ZONING BOARD OF APPEALS
Regular Meeting Agenda
Wednesday September 2, 2026
6:30 P.M.

Case Number: PZBA26-0005

Case Number: PZA26-0001

Applicant: Chuck Tombeau
Project Name: Commercial Building Renovation to Residential
Plan Date: January 15, 2026
Location: 1555 E. Michigan
Zoning: RC – Regional Corridor – Form Based District
Action Requested: Variance for Commercial Garage Door

1 SOUTH EXTERIOR ELEVATION
A.10 1/4" = 1'-0"

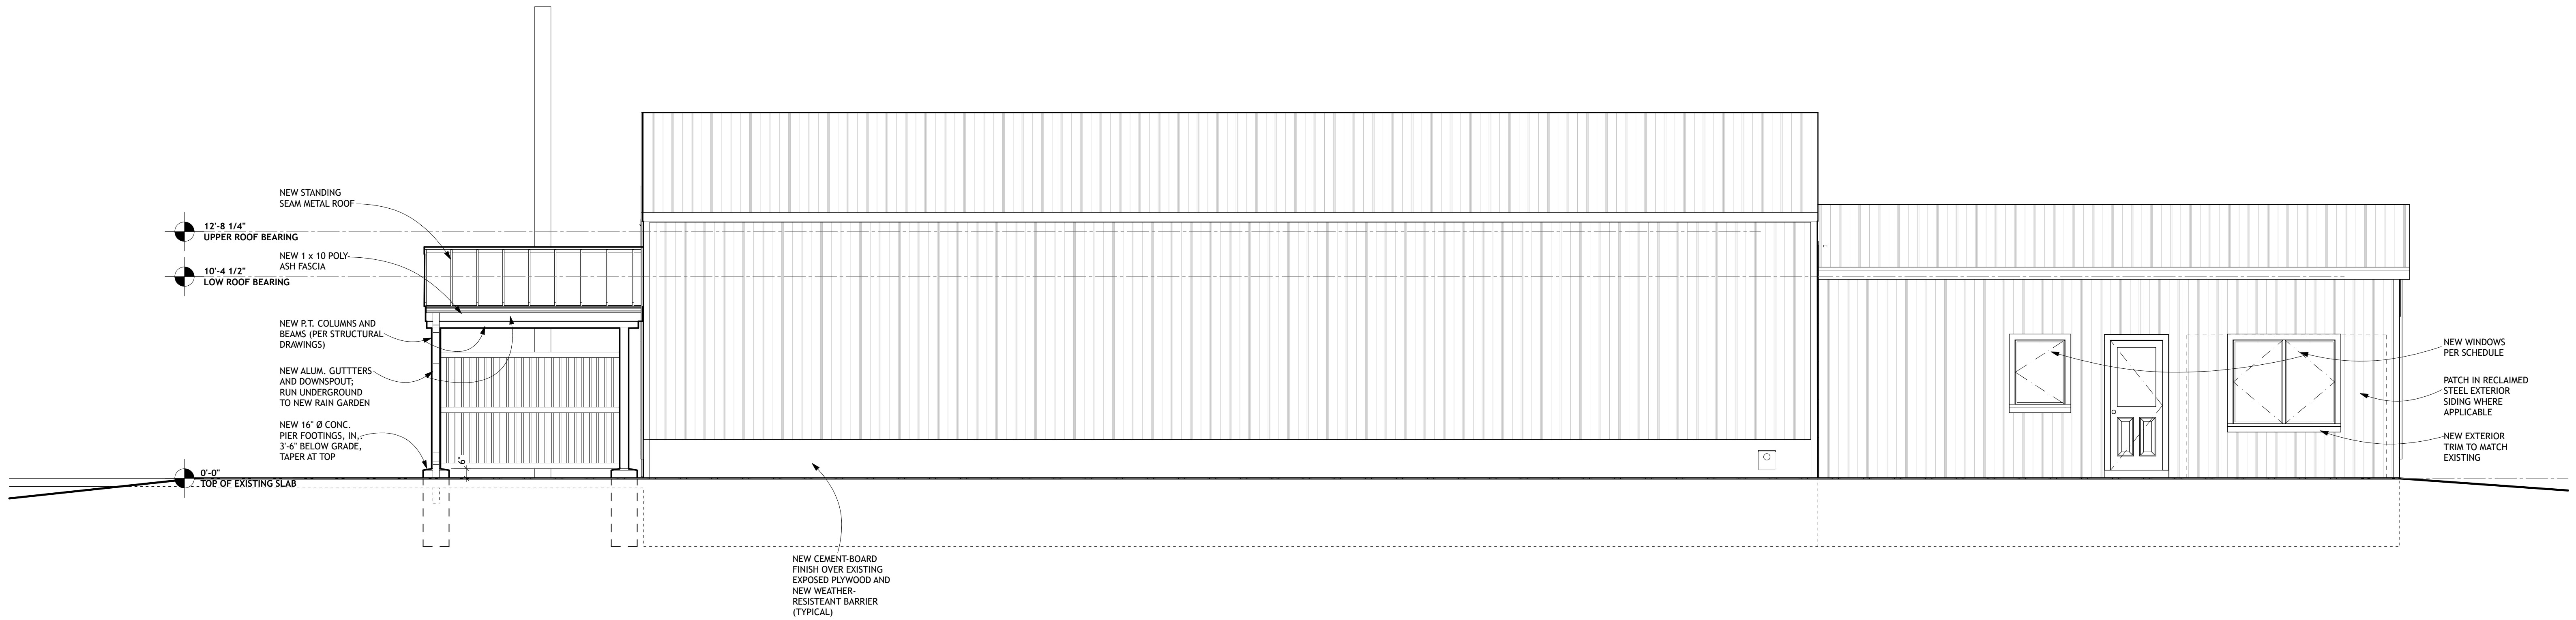
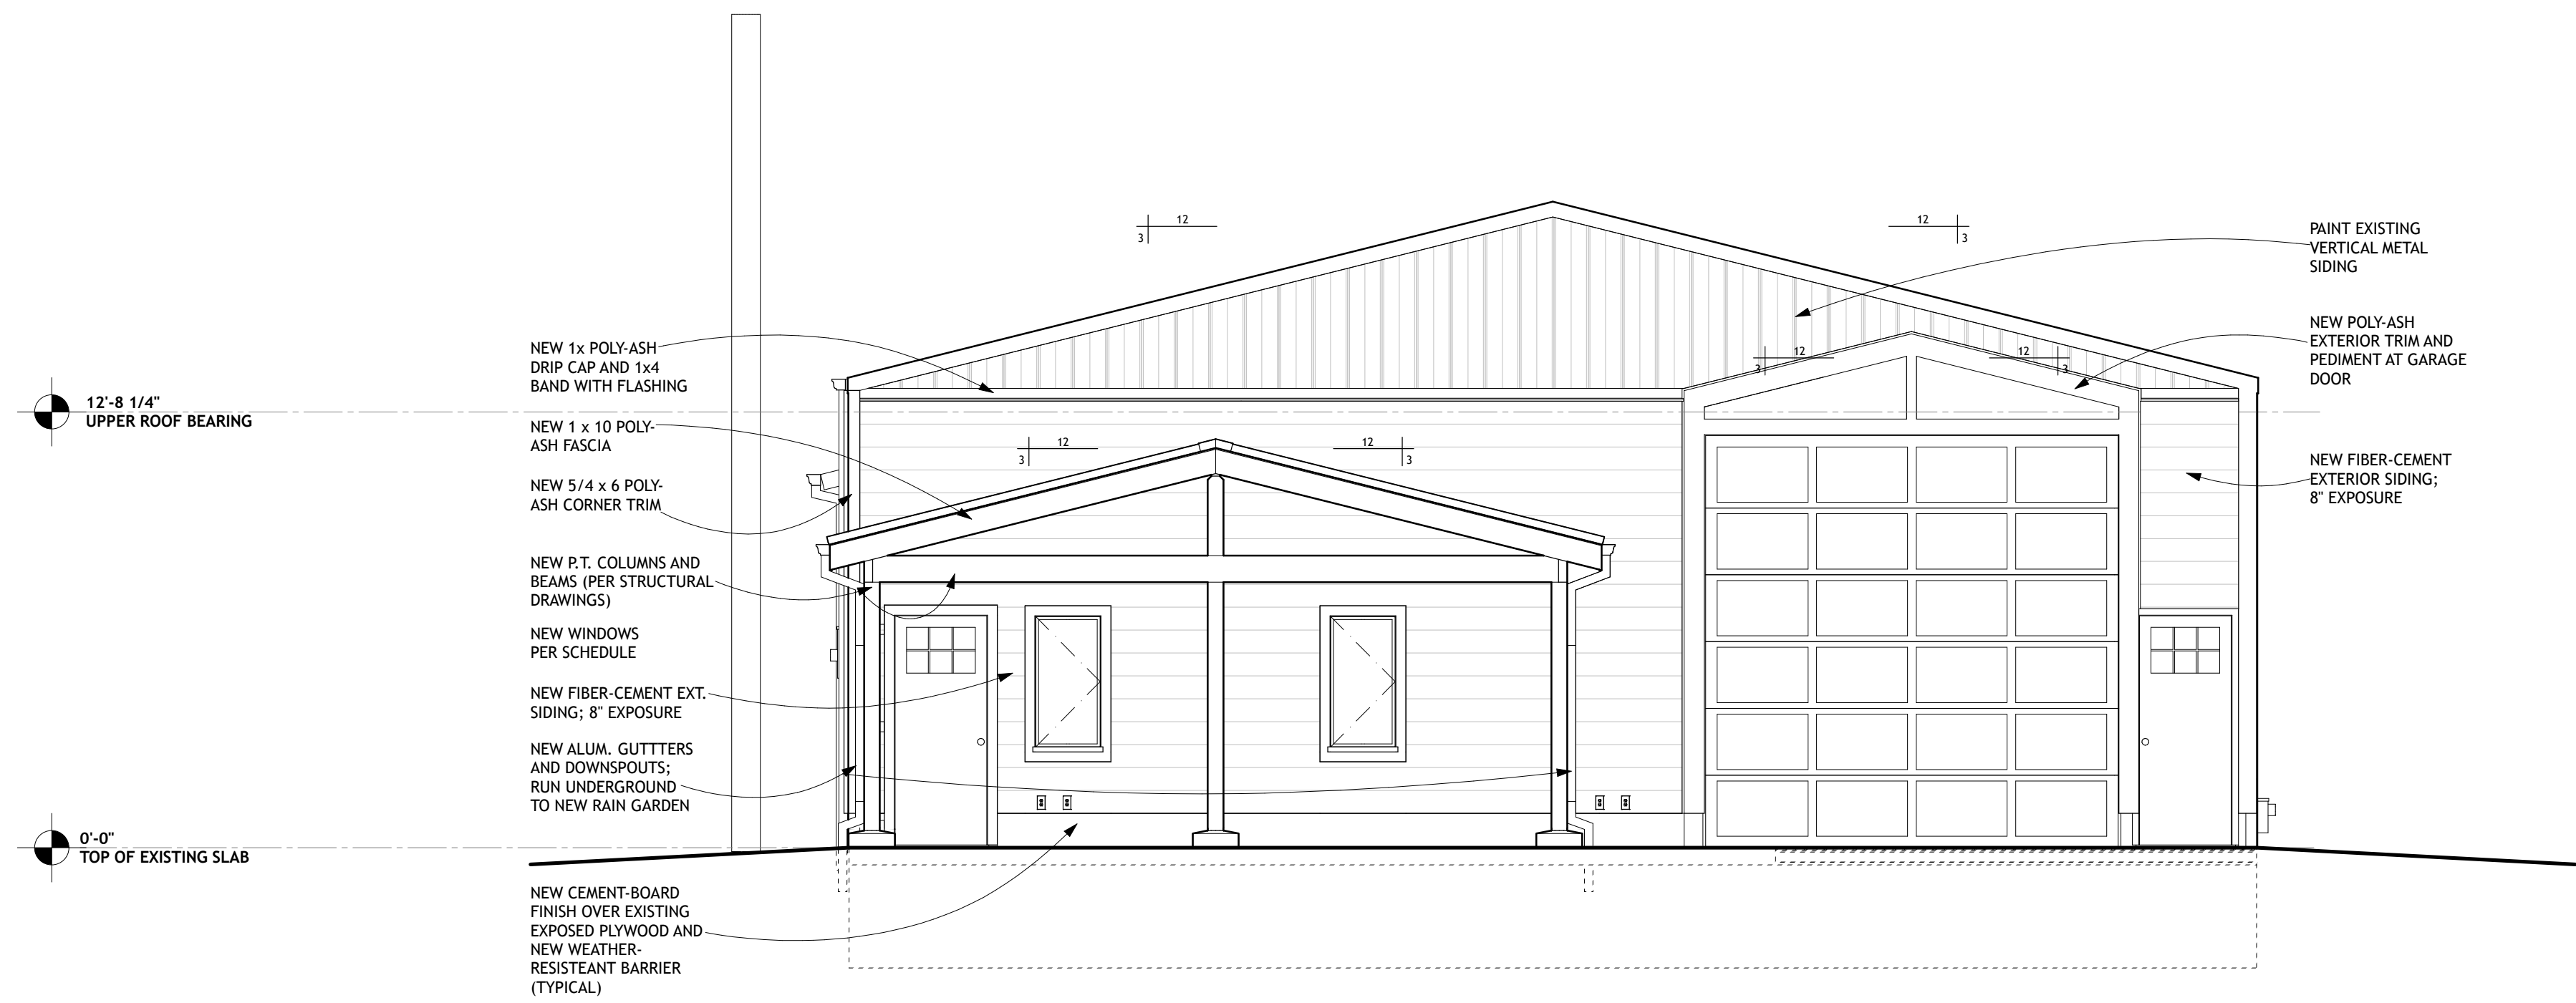
There is no information provided in the application that indicates the land poses any exceptional or extraordinary circumstances to create a practical difficulty in installing a residential-sized garage door on this building. The applicant's narrative states that the taller door is an existing feature of the existing commercial building, and that it would be expensive to replace it with a typical residential garage door. The fact that the existing building has a large, commercial door should be evaluated under the criteria "...any other physical situation on the...building...deemed by the Zoning Board of Appeals to be extraordinary." If the ZBA determines that the existing garage door on the building is determined to be an "extraordinary" physical situation that does not apply generally to other properties or classes of uses in the Regional Corridor zoning district, then this criterion is met.

My current building plan with the 12ft garage door has many more features that would have a greater positive impact on the neighborhood and community than replacing the 12ft garage door. I am also planning on planting multiple trees, adding a porch and rain garden, installing extra windows and siding to break up the visual pattern. I'm also planning on repainting the front of the building including the garage door so that it blends into the building.

When discussing with my architect he stated that these taller garage doors are common in residential areas to accommodate boats and RVs. Keeping the existing door would give me greater flexibility with the space should I want to sell the building in the future to buyers with those types of vehicles or a wheel chair accessible van.

SHEET TITLE
PROPOSED SITE PLAN

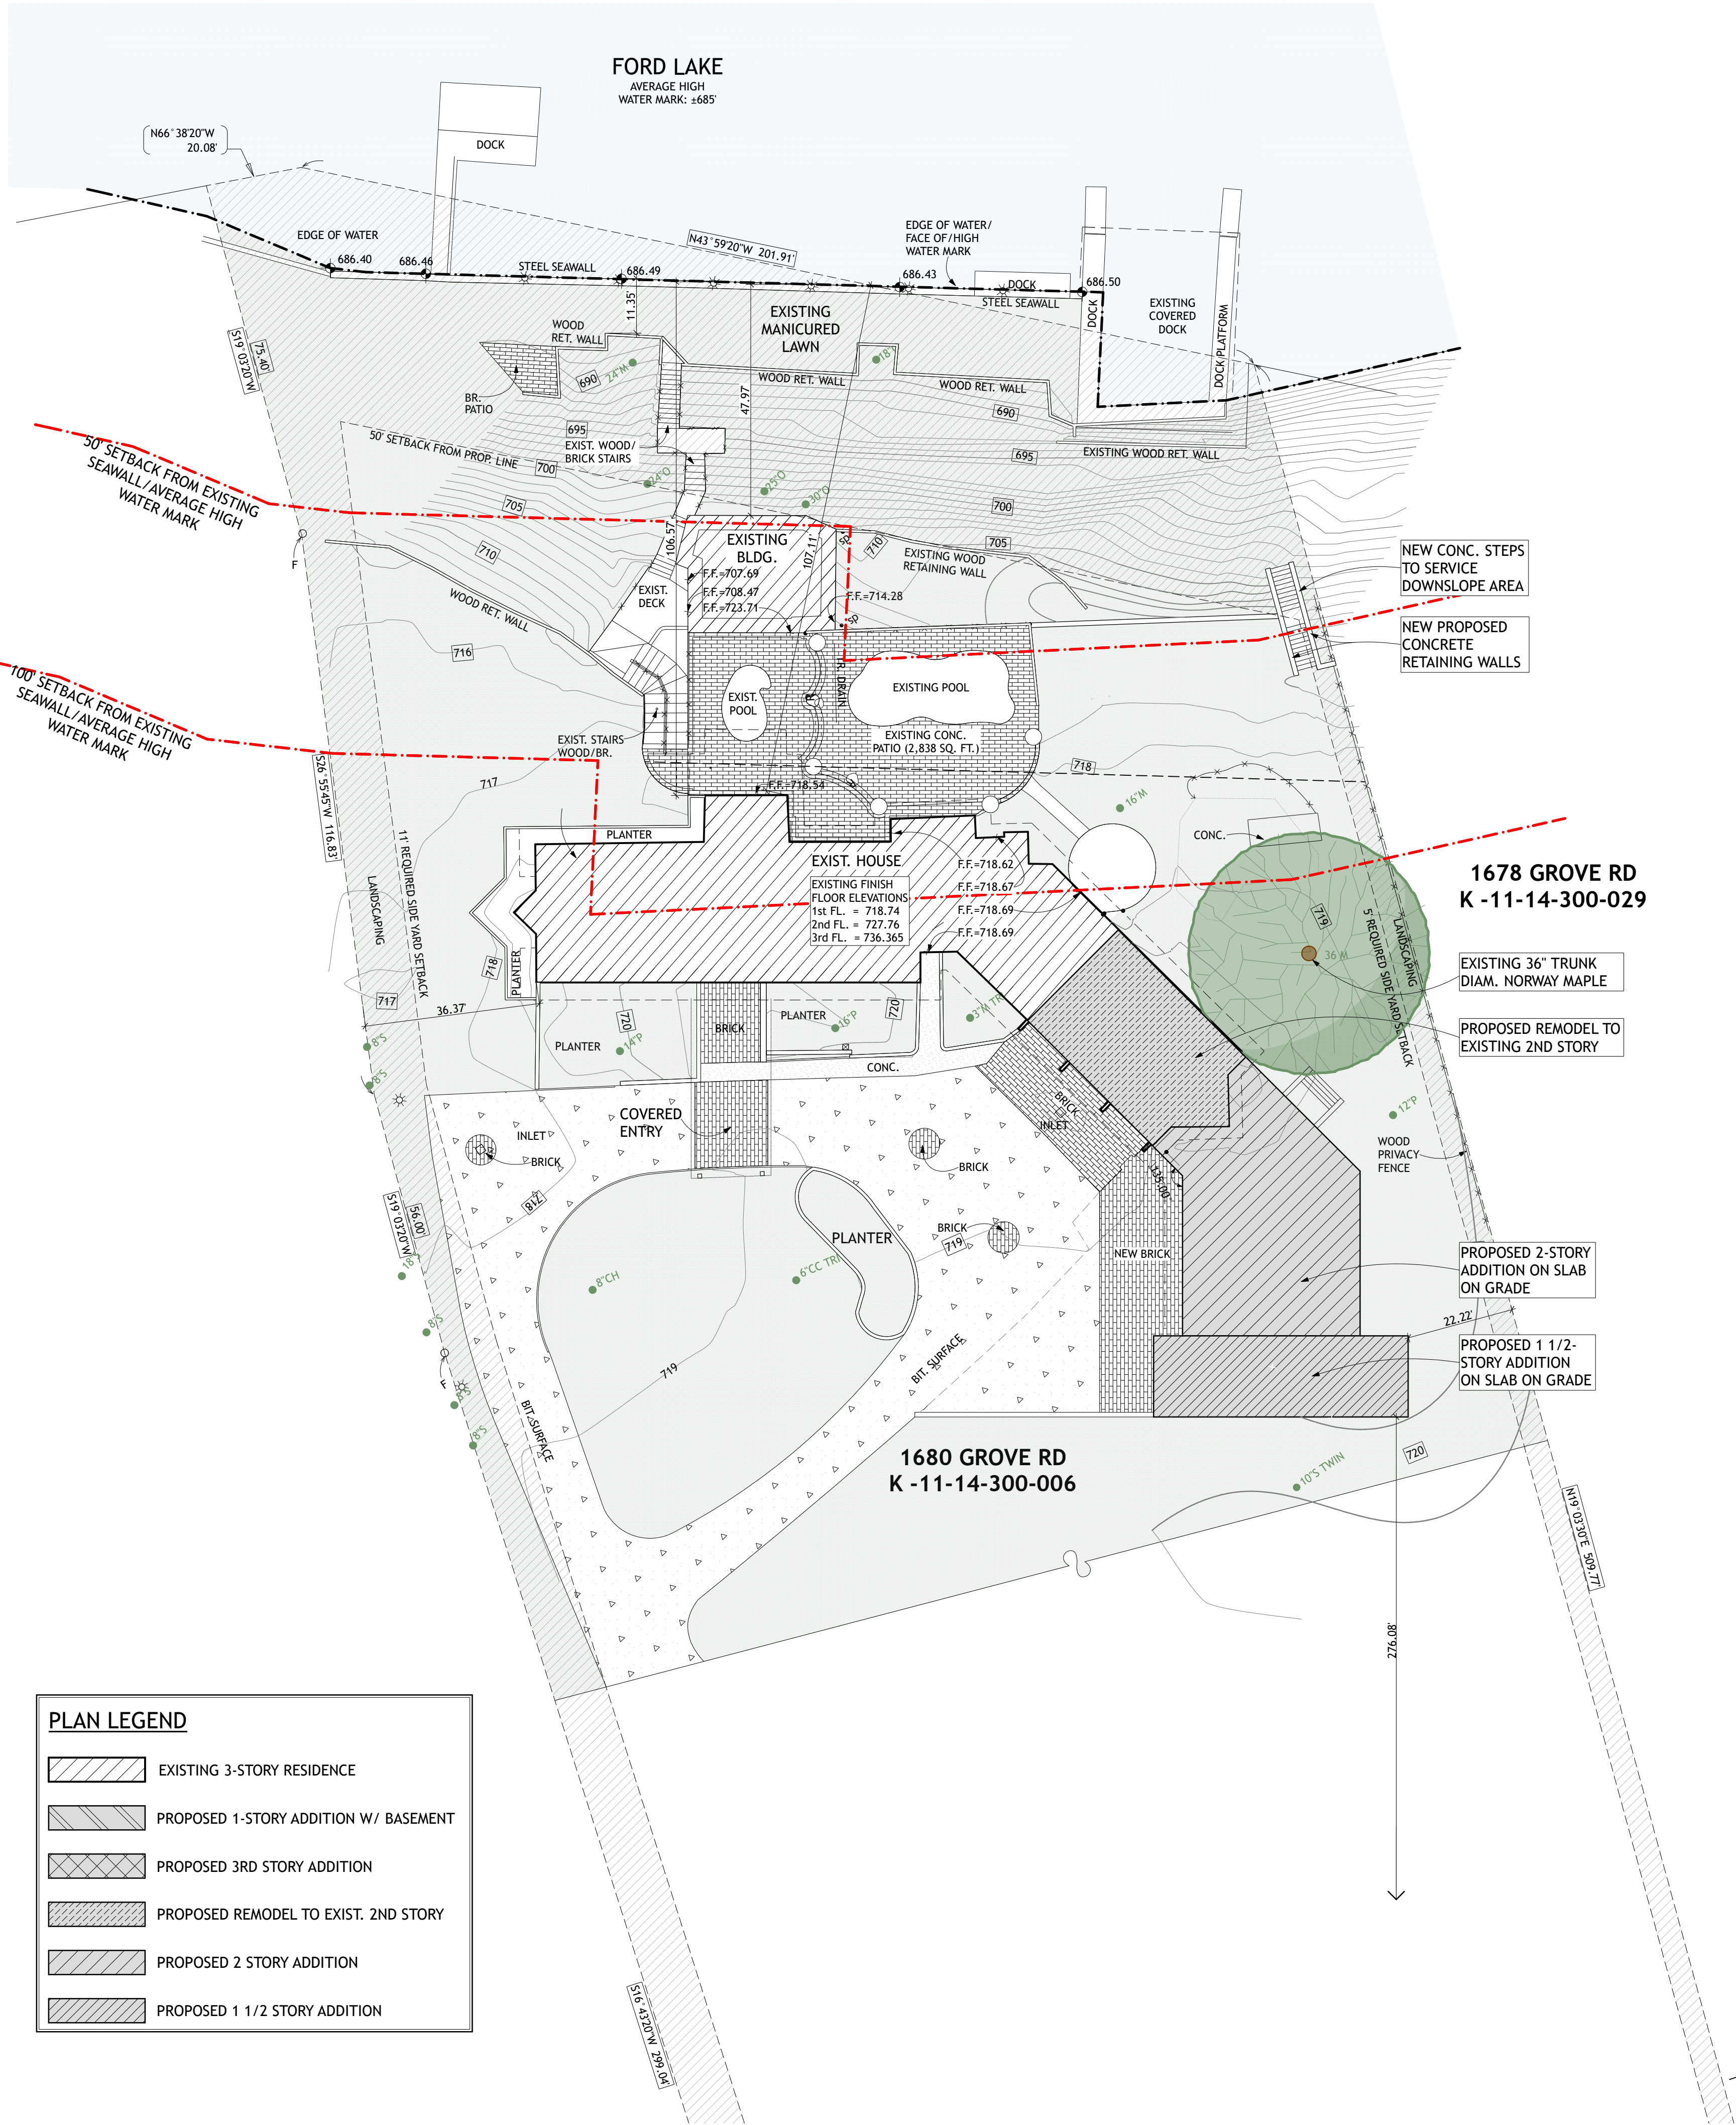
Variance #4 (Pool/Accessory Building within 100' of setback) Staff concludes that the existing pool and building location, which at one time was conforming to the zoning code, could not be added without encroaching into the setback.

Variance #5 (50' No Disturbance Setback) While the new request is to only replace and create a retaining wall, there is an approximate 20' difference in elevation, which may be considered the need for a retaining wall.

Variance #5: (50' No Disturbance Setback): While the existing retaining wall may have been self-created by previous property owners, the need to replace it may be considered justified and necessary to prevent erosion as the property and

Our interpretation of the feedback from the ZBA was that the Pool-House Retreat addition was unlikely to be approved, so we have currently removed it from the proposed scope of work. As the new work on the third floor does not add livable floor area and this addition has been removed, the need for this Variance request should also be eliminated.

1 NORTH EXTERIOR ELEVATION (PROPOSED)
A.11 1/8" = 1'-0"

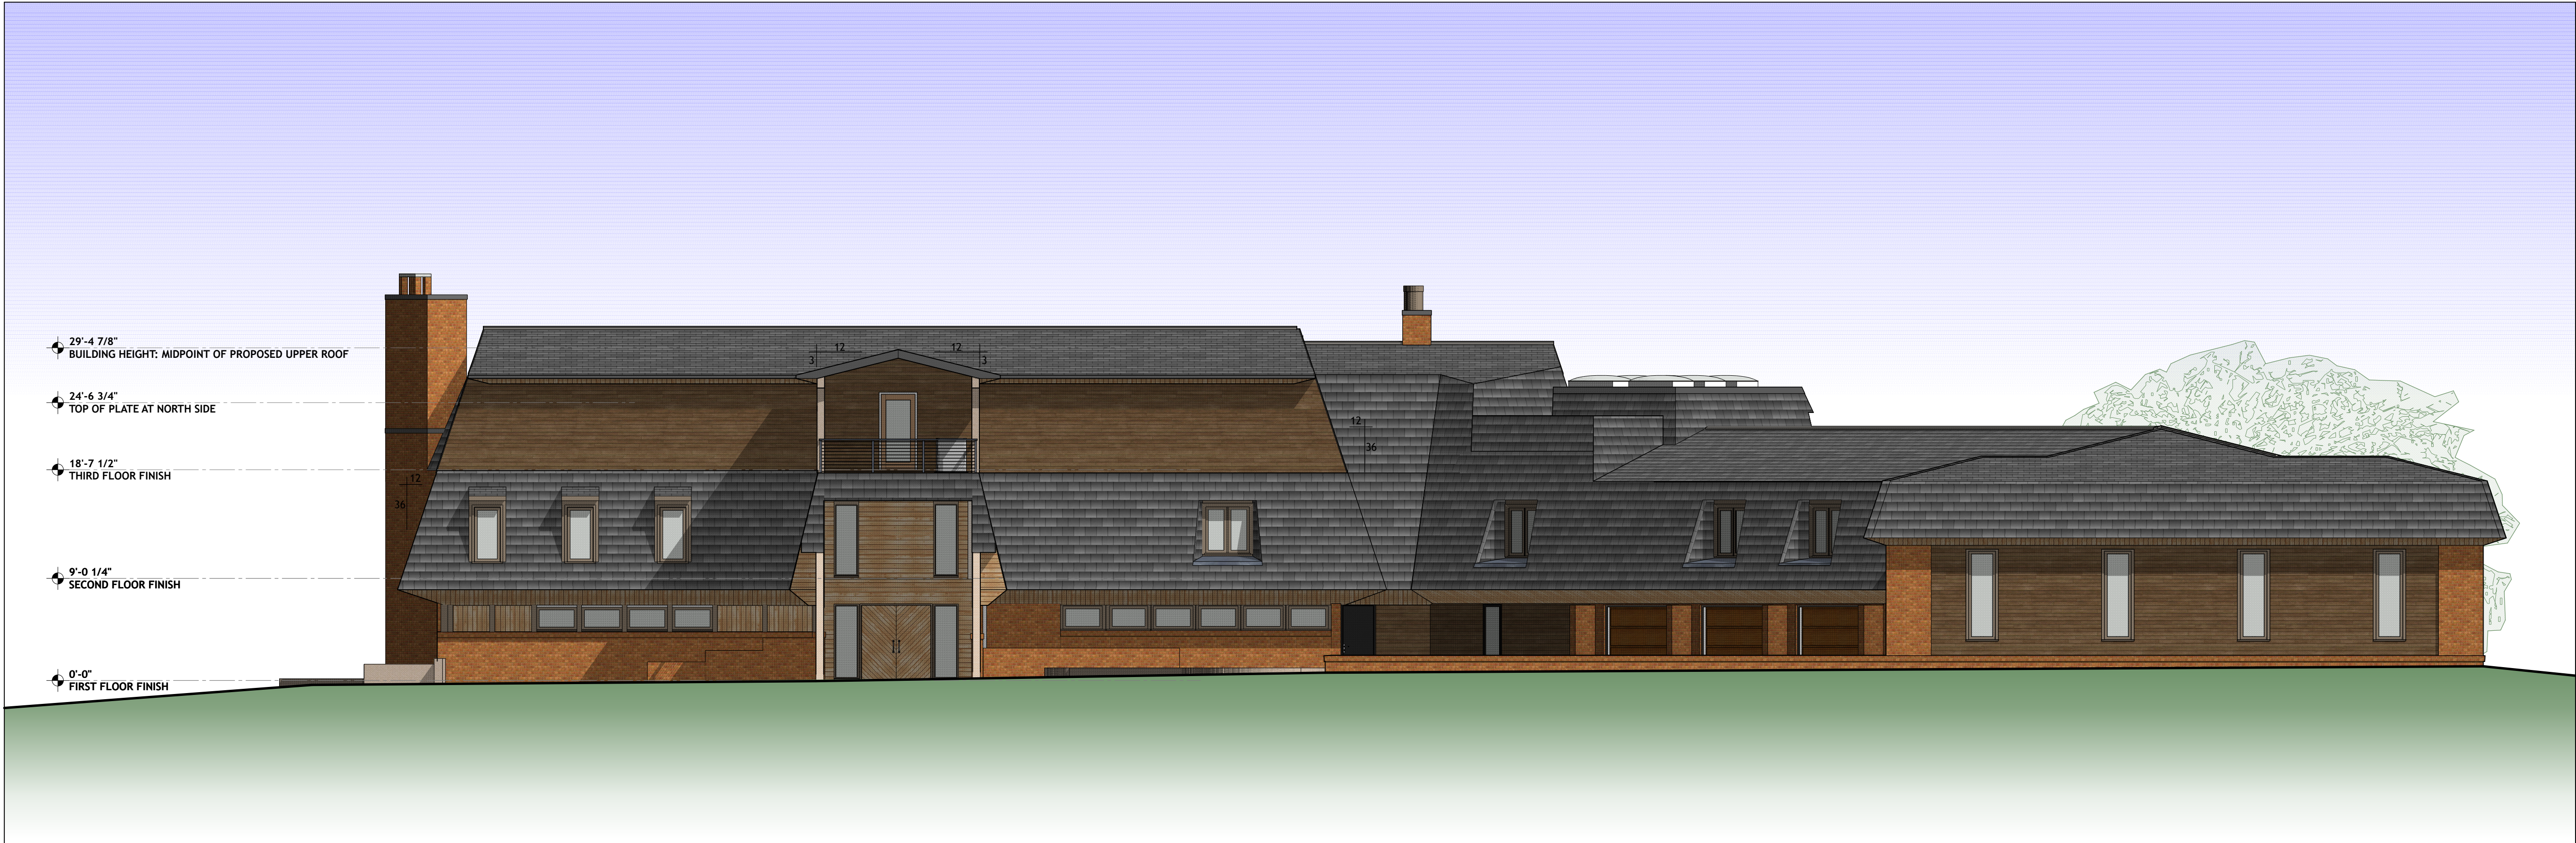
Variance #1 (Height): The proposed modification to a pitched roof as opposed to the current flat roof may be seen as necessary to maintain the structural integrity of the home with heavy snow and rains.

Variance #1 (Height): The proposed modification to a pitched roof as opposed to the current flat roof may be seen as necessary to maintain the structural integrity of the home with heavy snow and rains. This pitched roof is typical for most homes in the Township.

Variance #1 (Height): The proposed modification to a pitched roof as opposed to the current flat roof may be seen as the minimum necessary to fix any potential issue with snow and rain collecting on the roof and affecting the long term condition of the roof and structure.

I understand that the proposed extension of the existing 3rd level, and converting the existing flat roofs to pitched roofs, will require a variance from both the max height and 3rd level ordinance. Granting these variances will not be a detriment to my property--the distance between the section of the home seeking variances is far from the property line so there is no impact on my property resulting from sun-blocking/shading. I believe the proposed plans will enhance the character of the area because they will improve the appearance of 1680, and the sloped roofs will reduce the risk of a substantial impairment to 1680.

The space originally designated as the Third Floor expansion will serve as a storage and mechanical attic. Despite its substantial size, the home has no basement, and storage and mechanical space is at a premium, so this will provide an opportunity for that. Doors will be installed to access and service the various remaining balconies and roofs.
